Calderwood Urban Development Project

Section 75W Application

Water Cycle and Flood Management
Strategy Updates

Post-Exhibition Report

Plate 9-1- Initial Flooding Concerns surrounding Stage 1

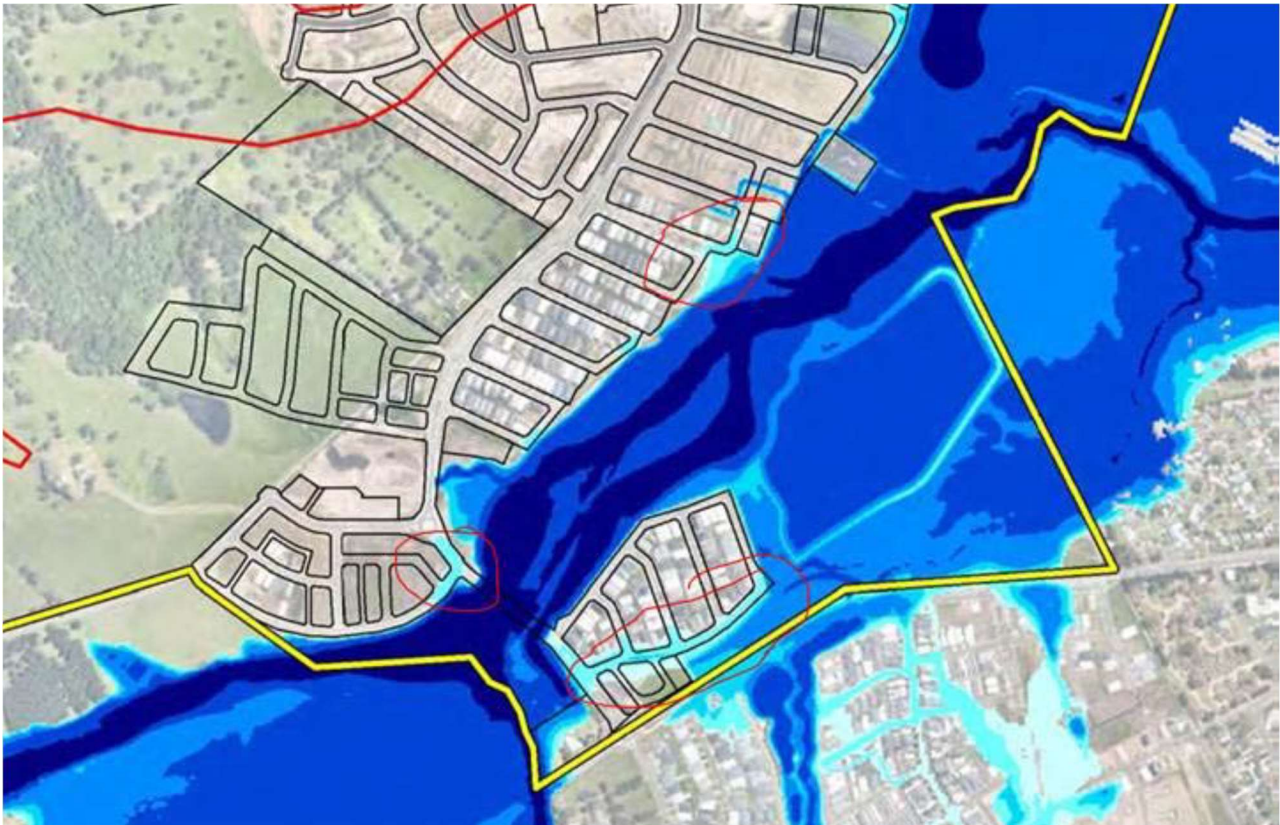
As part of the public submission process for MOD 4 SHCC raised specific concerns with the potential flood impacts surrounding Stage 1 of CUDP and the associated Stage 1 bridge across the Macquarie Rivulet that the new WMAWater flood assessment indicated. Plate 9.1 below shows that initial flood impacts that were the bases of SHCC concerns.

While it is noted that the initial flood mapping of the developed conditions which supported the MOD 4 Strategy did show impacts within Stage 1 (Plate 9.1 above), the suggestion that this new assessment renders the MOD 3 and the subsequent construction approved granted by SHCC invalid is unjustified. SHCC's position is that the Stage 1 bridge now needs to be lifted.

Plate 6 – PMF Impacts as per Consolidated Concept Plan (March, 2011)

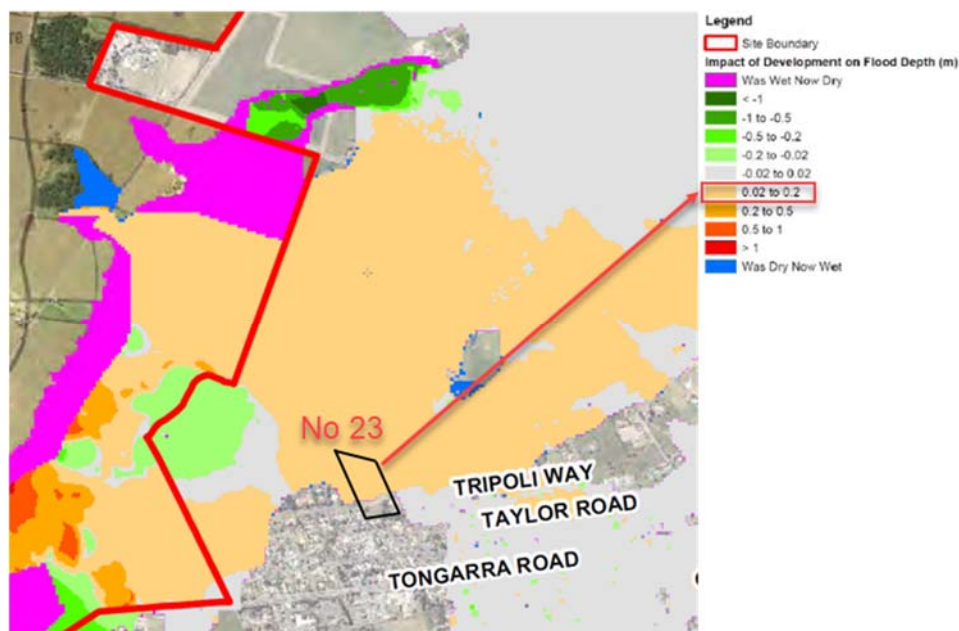
Rienco have stated that impacts in the PMF event have increased in comparison to the PMF Impacts for Stage 1 Project with the lengthened bridge over Macquarie Rivulet (March 2013). While this is acknowledged, it should be noted that the PMF impacts in WCFM indicated in Plate 8 above is less than the 0.3m agreed flood impacts.

Plate 6 from the Rienco submission depicts PMF impacts as per Consolidated Concept Flood Plain Risk Management Study (2010). It is evident from this plate that the part of the site is inundated with depths up to 0.2m in the PMF event.

Plate 7 – PMF Impacts from Watercycle and Flood Management Report (JWP, 2018)

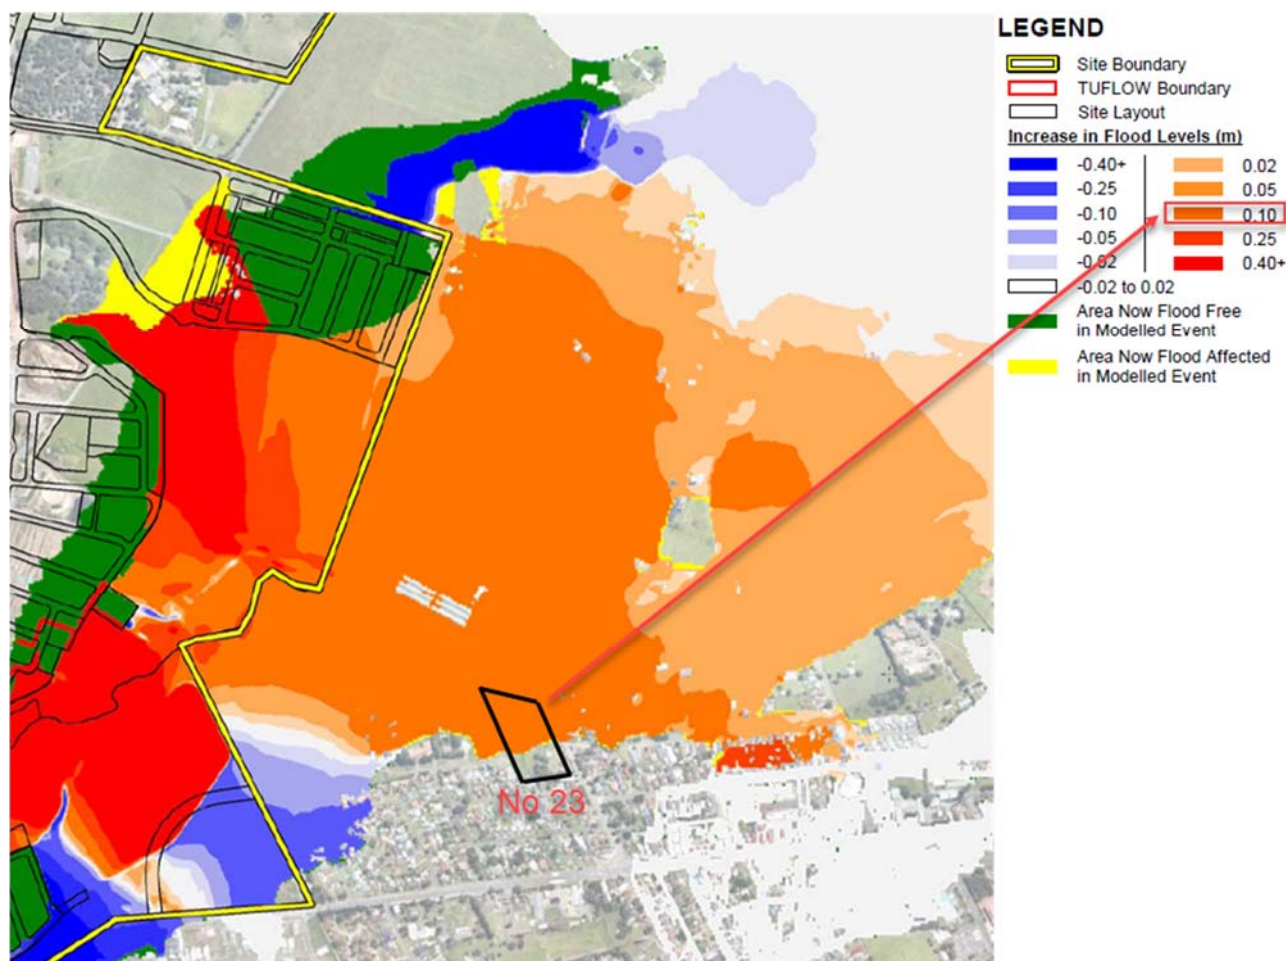
The legend in Wyndham Prince Figure 11 which shows increased flood levels in the PMF event in the vicinity of Tripoli Way and Taylor Road also lacks clarity. A specific water level difference is assigned to each of the various colours used to indicate a change in flood levels, but it is assumed that each colour refers to a water level difference range and the specified water level difference is the lower limit within that range. For instance, there are 5 orange/red colours of increasing intensity used to denote water level increases. The third-ranking such colour, a medium orange colour, is assigned a water level difference of 0.10 m. It is assumed however that what is meant is that this colour represents all areas where the water level difference is between 0.10 and 0.25 m.

Figure 11 of WCFM (extract provided below in Plate 7) does not show increased flood levels in PMF along Tripoli Way. It is quite the opposite. The PMF flood depths in Figure 11 are up to 0.1m which is lower than the Approved Concept Plan.

While this is acknowledged, the colour coding implemented in Figure 11 identifies the flood impact graduation which represents flood impacts up to (but not greater than) the specific depth shown.

Plate 8 – Approved Concept Plan Approval Cut and Fill Plan

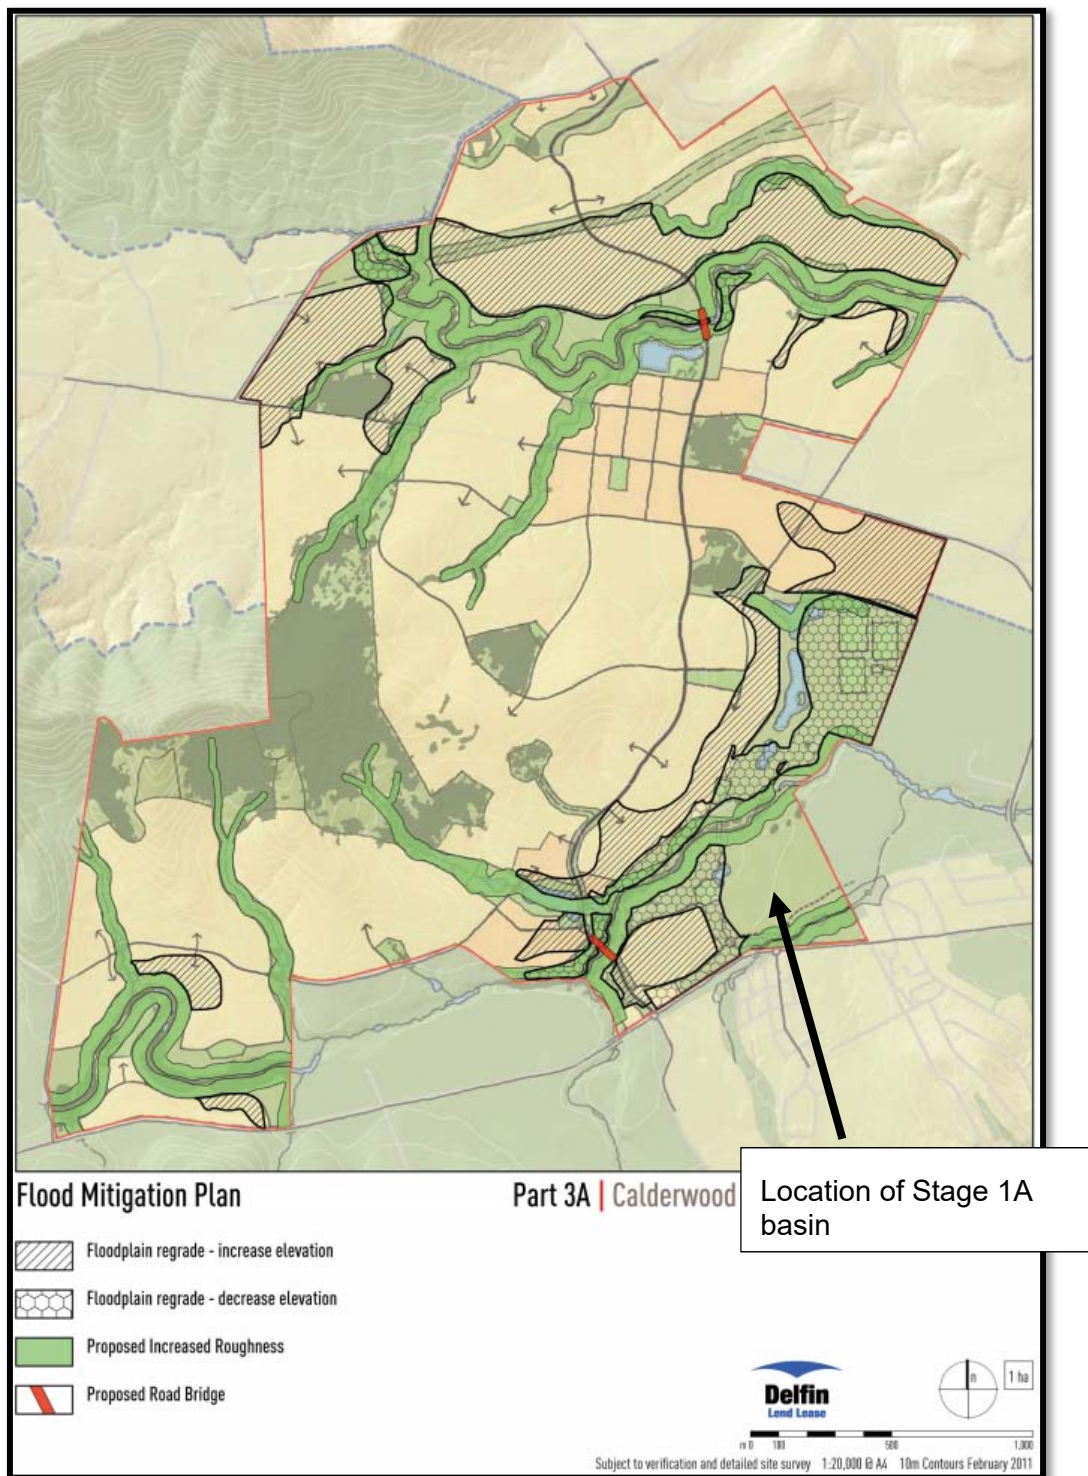
J. Wyndham Prince's Figure 3 (cut and fill plan) is inconsistent with bulk earthworks plans submitted to Shellharbour City Council in support of DA0586-2017 (still under assessment), which show extensive fill within areas designated as cut on the Consolidated Concept Plan Figure C11.

J. Wyndham Prince's Figure 3 also indicates substantial changes to cut and fill areas on the floodplain of Marshall Mount Creek in comparison to the approved cut and fill areas on Consolidated Concept Plan Figure C11.

See Plate 8 below for details.

Nevertheless, a revised cut and fill plan is present in figure 8.10 the Post Exhibition WCFM report which includes locations and depths of the proposed cut and fill.

Figure 8.04

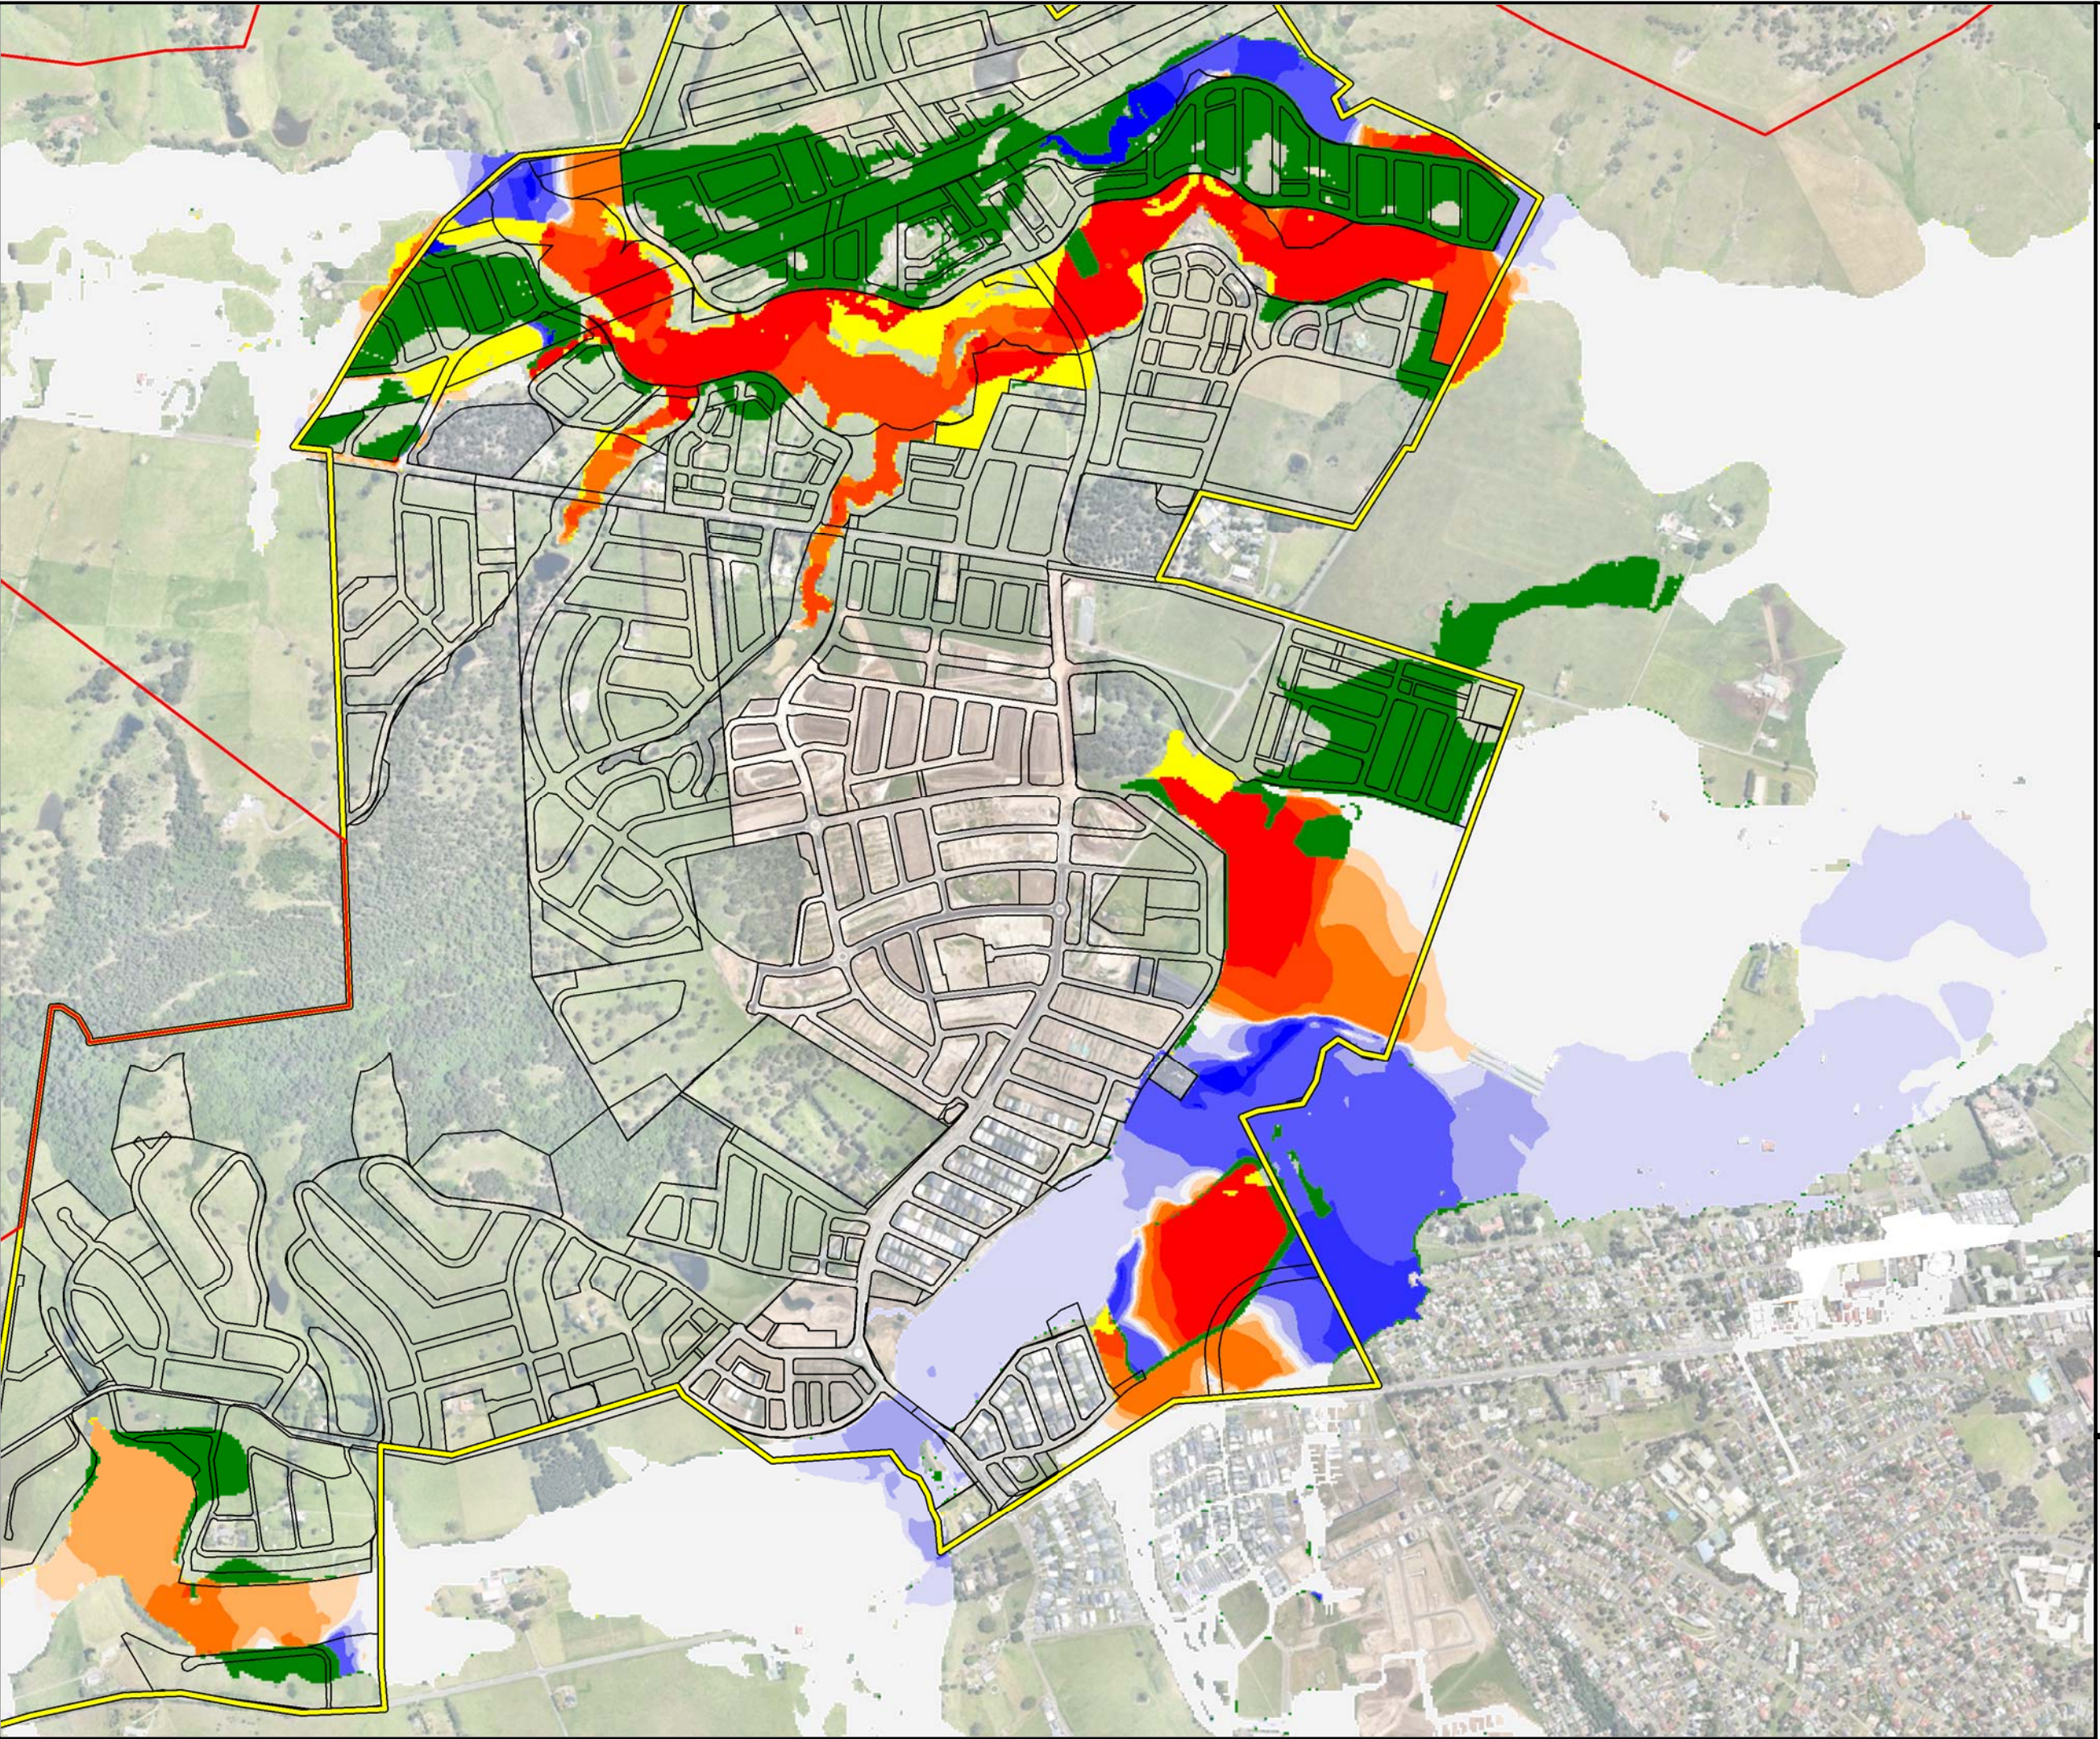
Figure 7 of the report indicates significant flood affectation in the 1% AEP (Annual Exceedance Probability) in Stage 5 south. Apart from being a poor outcome for a greenfield site, no evidence has been provided on how the flood risk to future development will be managed and whether the flood planning level (i.e. 1%AEP + 0.5m) will be achieved.

Stage 5 south is not flood affected in the 1% AEP and is located on the northern side of North Macquarie Road (refer to Figure 4 Indicative Subdivision Plan in the Environmental Assessment Report prepared by Ethos Urban dated 24 July 2018). WCC is likely referring to the “non-core” land located on the southern side of North Macquarie Road (refer to DA No 577/2017). Nevertheless, the original modelling surface did not account for the proposed development at 128 North Macquarie Road, Calderwood (non-core landowner). The surface information has been updated as part of the revised Watercycle and Flood Management Strategy to reflect this proposed development, and Figure 8.04 indicates that 128 North Macquarie is now flood free.
